SI M33 01 14
Rear Axle

SB-10056090-1237

Delivery Stop/Service Action: Shock Absorber Rear Axle

F56 (MINI Hardtop)

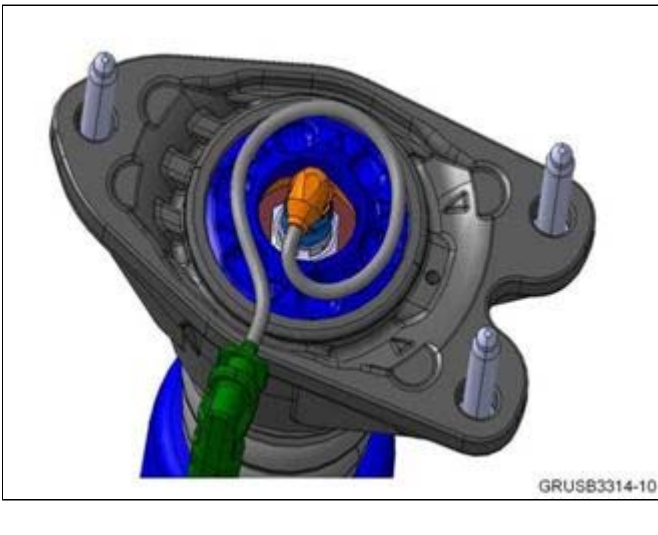
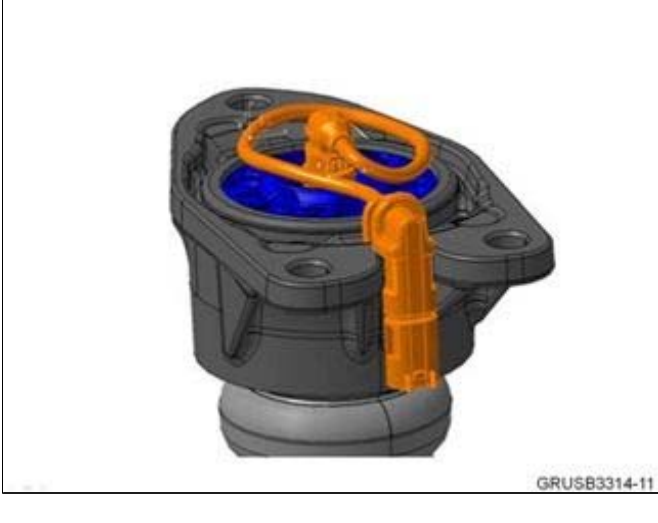
First check if a Service Action label with a code number **67** is already attached to the B-pillar.

If a code number **67** has been punched out, the Campaign has already been performed and no further action is necessary.

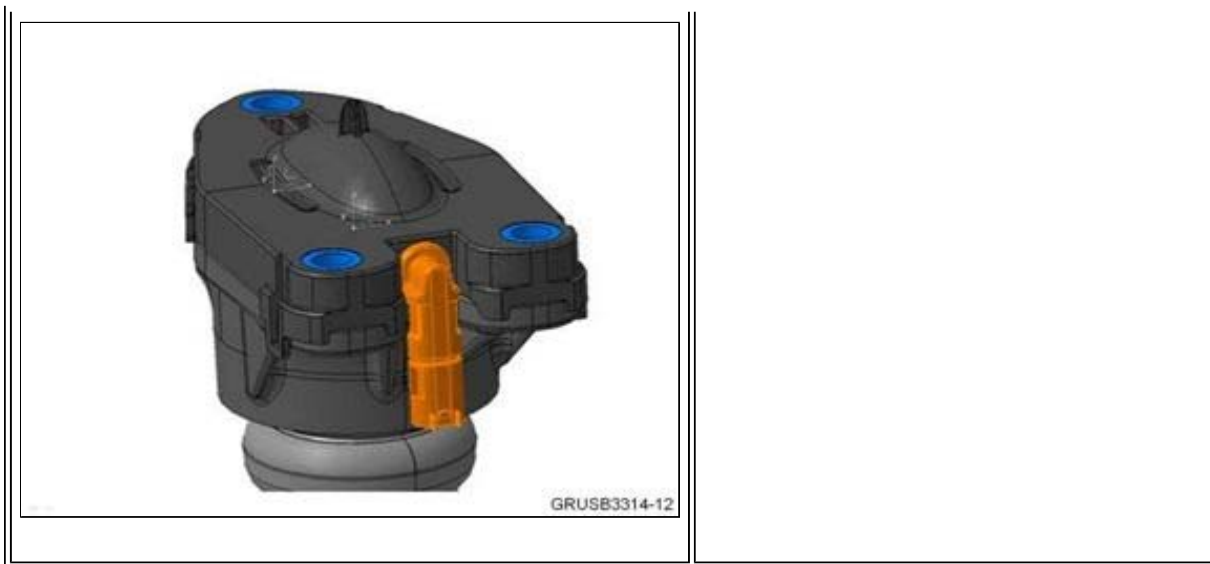
Correctly position the VDCO cable as shown.

<p>When positioning the connecting cable on the new shock absorber, both cables must be in one line.</p>
	<p>Turn both plugs in the installed position. Push them down until they snap into place.</p>
	<p>Fit the adapter plate</p>
